**FIRST ADDENDUM TO THE
SUPPLEMENTAL ENVIRONMENTAL IMPACT REPORT
FOR THE OAKLAND ARMY BASE AUTO MALL
PROJECT**

**ADDRESSING PROJECT CHANGES RELATED TO SITE LAYOUT AND
ADDITIONAL INFORMATION ON TRAFFIC AND WASTEWATER**

**PREPARED FOR:
CITY OF OAKLAND**

December 2007

Figure 2: SEIR Compact Design Alternative with Mitigated EBMUD Driveway

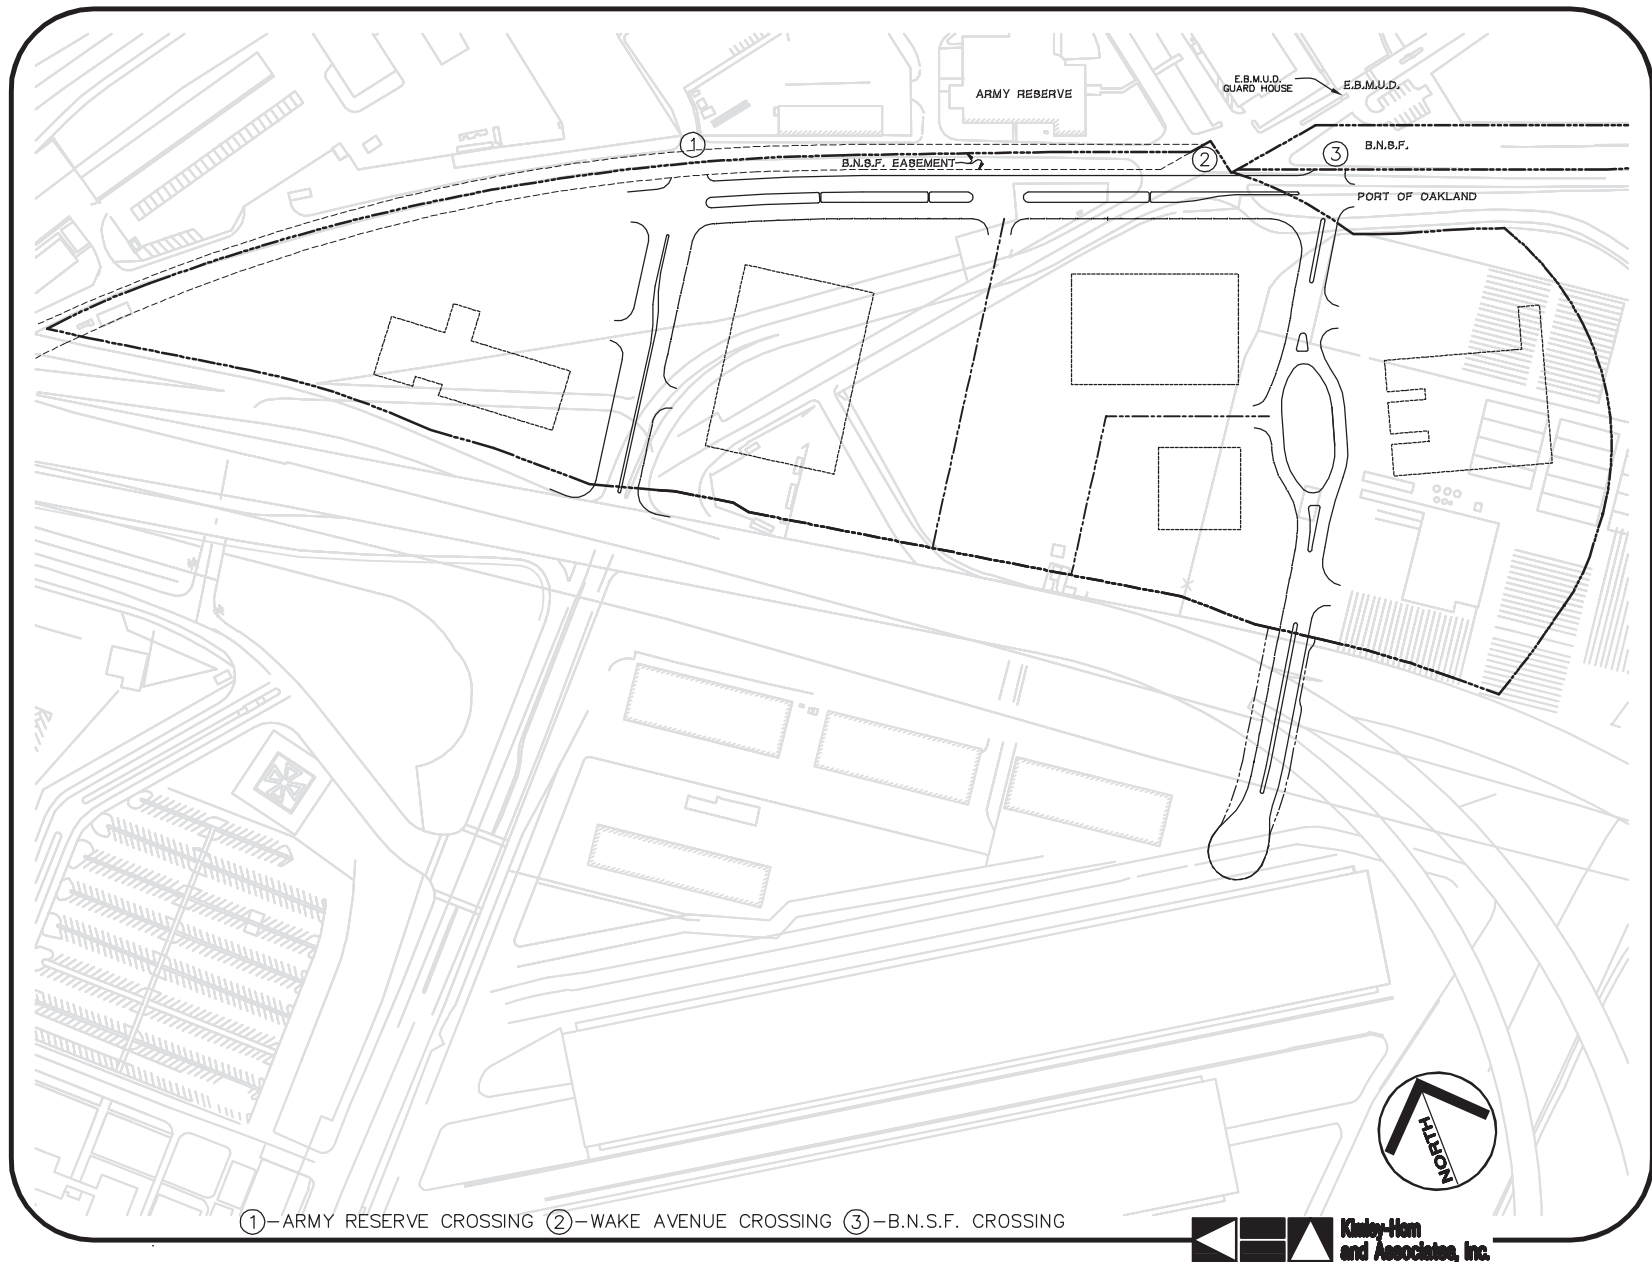
A preliminary design of this access option is shown in **Figure 2**, combined with the SEIR Compact Design Alternative. This mitigation measure was found to reduce potential design hazard impacts to a less than significant level.

While the SEIR identified one optional intersection configuration as mitigation to address the **potential** design hazards at the EBMUD access intersection, other possible intersection design options are now considered as more feasible. These other possible options are shown in **Figure 4: EBMUD Access - Dedicated Left Turn Lane Option** and **Figure 5: EBMUD Access - Left Turn Pocket Option**. The following Traffic chapter of this Addendum includes analysis of these options for providing access to the neighboring EBMUD facility to ensure reasonable and safe access.

Figure 4: EBMUD Access - Dedicated Left Turn Lane Option

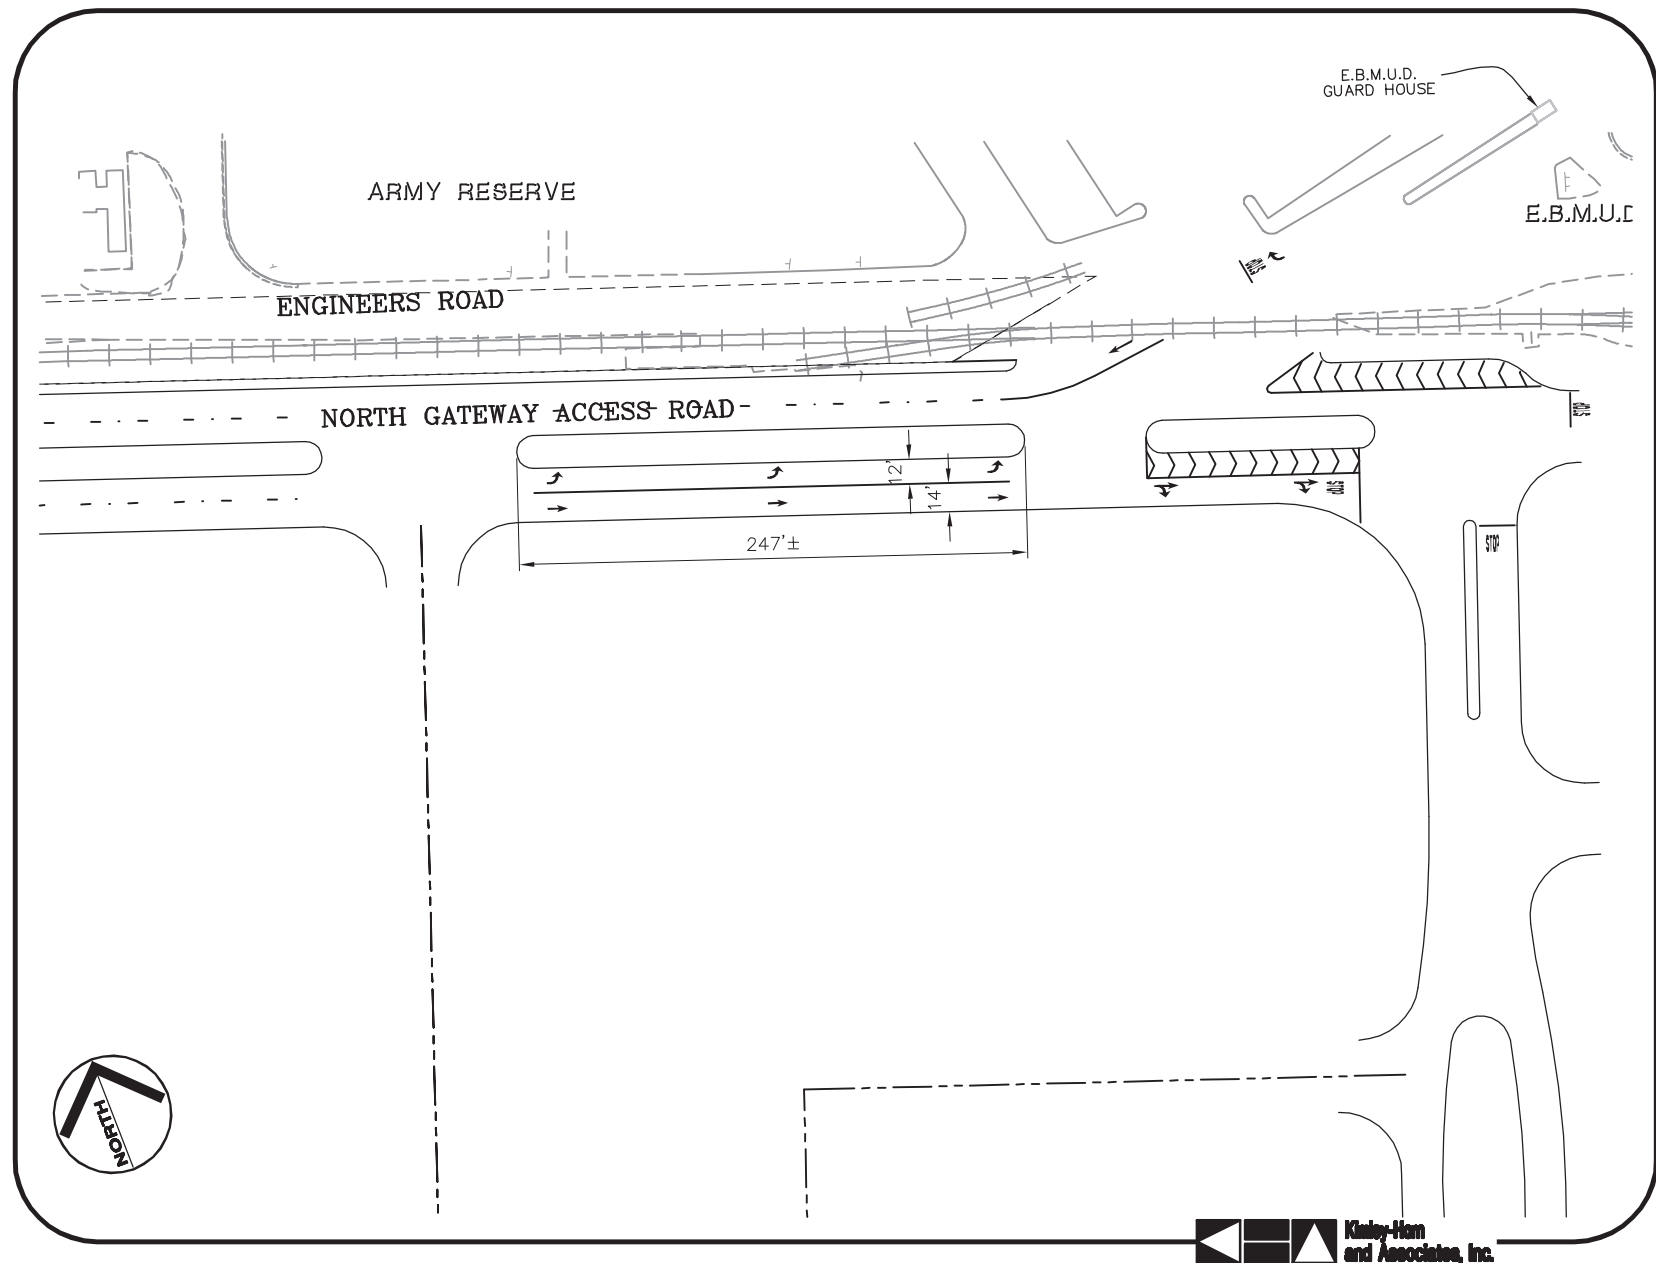
The Dedicated Left Turn Lane option (Figure 4 on p.11) represents a refinement of the less-well-defined intersection geometry evaluated in the SEIR. The Dedicated Left Turn Lane option is described as follows:

- The eastbound lanes on the North Access Road would include one dedicated left turn lane into the EBMUD driveway and one shared through/right turn lane. The relatively light volume of through and right turn traffic would be easily accommodated in one shared lane. A median would separate eastbound and westbound lanes. The dedicated left turn lane would provide 250 feet of storage for vehicles entering the EBMUD driveway beyond the first median break, and additional storage as far back as the Maritime

The Dedicated Left Turn Lane option would include a stop location to the north of the rail line for vehicles exiting the EBMUD driveway, a location which would provide adequate lines of sight for vehicles using the North Access Road/EBMUD driveway intersection. This option would not change the existing skewed rail crossing at the EBMUD driveway. The skewed rail crossing is less than ideal in its existing state because southwest-bound drivers approaching the EBMUD driveway would have a difficult time seeing a train approaching over their left shoulder from behind. The skewed rail crossing has not been identified as a high priority for remediation due to the slow speed of trains using this rail line (maximum 10 mph), the low volume of both motor vehicle and train traffic, and the lack of any known accidents at this location under these conditions. There is no reason to believe development of the Auto Mall project would have any effect on the safety of this skewed rail crossing. The Dedicated Left Turn Lane option does not make the existing skewed crossing any safer or less safe than current conditions because it does not change the existing angle of the crossing.

The dedicated left turn lane would provide more than adequate storage capacity to accommodate the maximum anticipated design queue at the North Access Road/EBMUD driveway intersection. The dedicated left turn lane and the combination through/right turn lane would each serve fewer than 300 vehicles during the peak hour. The vast majority of both EBMUD and auto mall traffic would be automobiles and both uses would accommodate

Figure 5: EBMUD Access - Left Turn Pocket Option

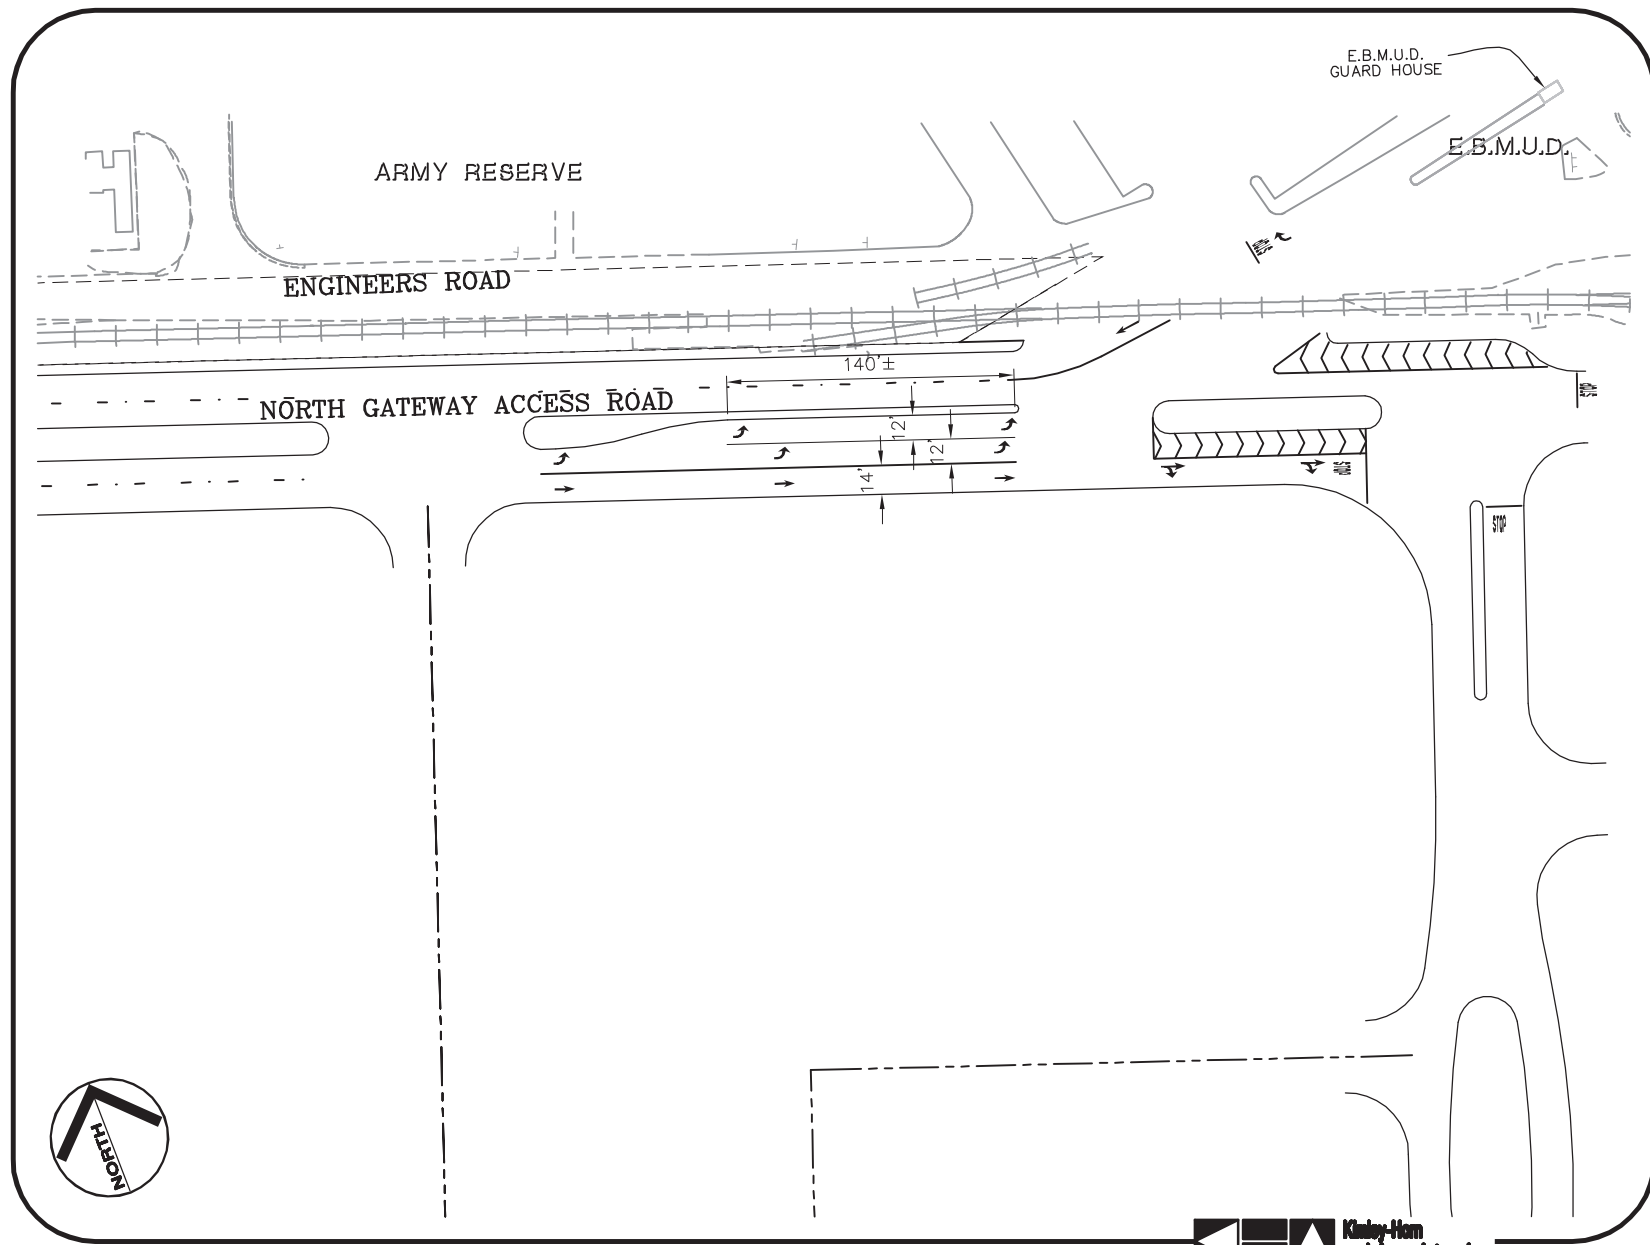
The Left Turn Pocket option (Figure 5 on p.12) represents a modification to the Dedicated Left Turn Lane option. The purpose of this modification is to consider an access design that accommodates EBMUD's stated preference for dual left turn movements into their driveway. The Left Turn Pocket option would be the same as the Dedicated Left Turn Lane option with the following exception:

As with the Dedicated Left Turn Lane option, this design option would maintain all existing driveways north of the rail crossing and would provide adequate lines of sight for vehicles using the North Access Road/EBMUD driveway intersection. The stop location for traffic exiting the EBMUD driveway would be located north of the BNSF spur tracks and would place exiting vehicles in a position to see vehicles approaching from all directions.

The Left Turn Pocket option would not change the existing skewed rail crossing at the EBMUD driveway. As with the Dedicated Left Turn Lane option, the Left Turn Pocket option does not make the existing skewed crossing any safer or less safe than current conditions because it does not change the existing angle of the crossing.

The Left Turn Pocket option would provide approximately 140 feet of storage in a dedicated left turn pocket for vehicles entering the EBMUD driveway in addition to a second left turn lane with more than 700 feet of storage capacity. As stated above, the 95th percentile design queue would be approximately 200 feet to accommodate the queue that could form in the

event of a 2-minute train blockage. Thus, the Left Turn Pocket option would provide more than sufficient storage capacity to accommodate the design queue.

Figure 6: Non-Port-Dependant Roadway Alignment Option

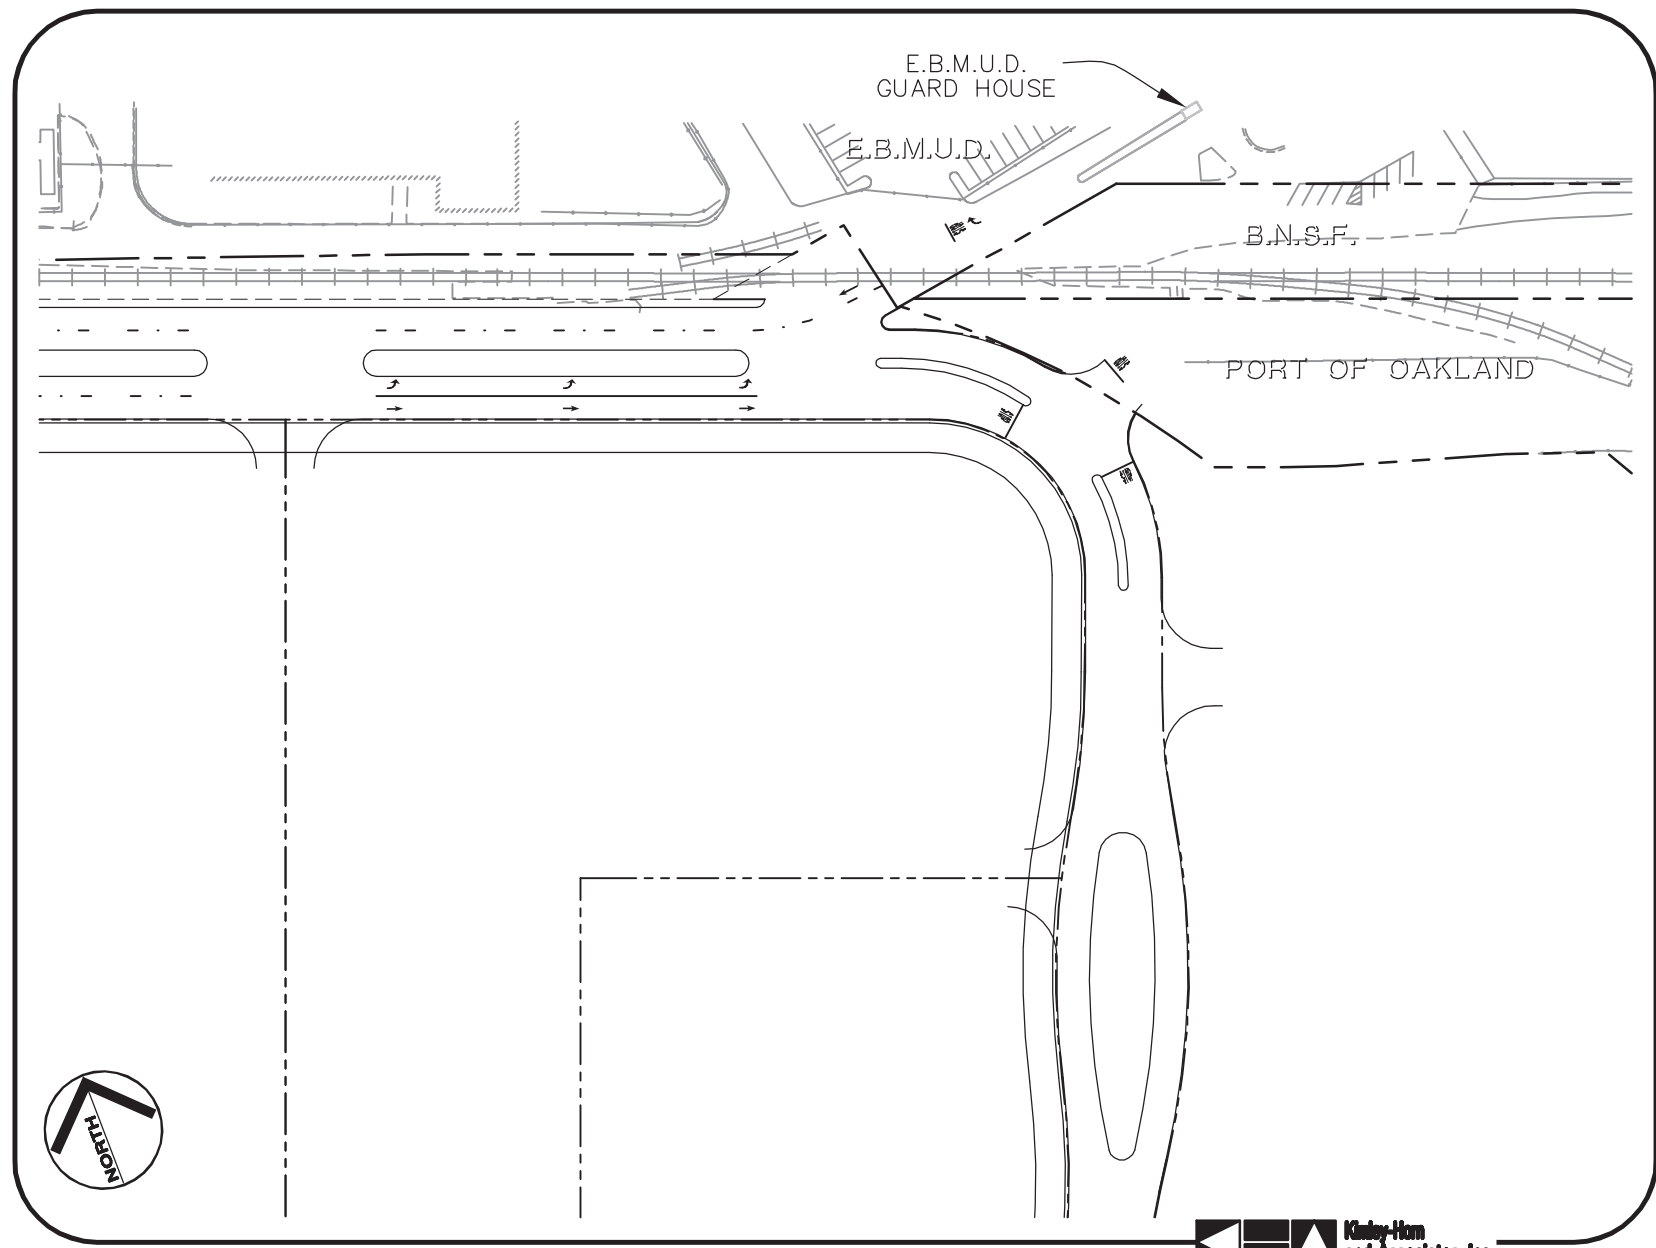
The Non-Port-Dependant Roadway Alignment option (Figure 6 on p.13) represents a slight change in the alignment of the North Access Road to avoid a small Port-owned parcel of land. While negotiations are underway to allow for construction on this parcel (likely involving a land swap between the City and the Port), this roadway alignment option would be considered in the event negotiations fall through or cannot be finalized in the timeline of the Auto Mall project. This alternative alignment of the North Access Road is an option independent from the EBMUD access options shown in Figures 4 and 5, and does not preclude either of these options. The Non-Port-Dependant Roadway Alignment option is described as follows:

The Non-Port-Dependent Roadway Alignment could be combined with either of the EBMUD access options and would not change any of the analysis or conclusions in this document. The capacity of the North Access Road and East Access Road intersection would be reduced slightly by combining the two eastbound lanes into one, but the remaining capacity would be adequate. The intersection would serve fewer than 300 total through vehicles on the main roadway and fewer than 10 vehicles at the driveway and would operate at LOS A during the peak hours of operation.

A refinement to the new preferred access options was evaluated. The refinement changes the alignment to avoid a small Port-owned parcel of land in the event negotiations with the Port for transfer of the land fall through or cannot be finalized in the timeline of the Auto Mall project. This option could be combined with either of the EBMUD access options and would not change any of the analysis or conclusions regarding the preferred access options.
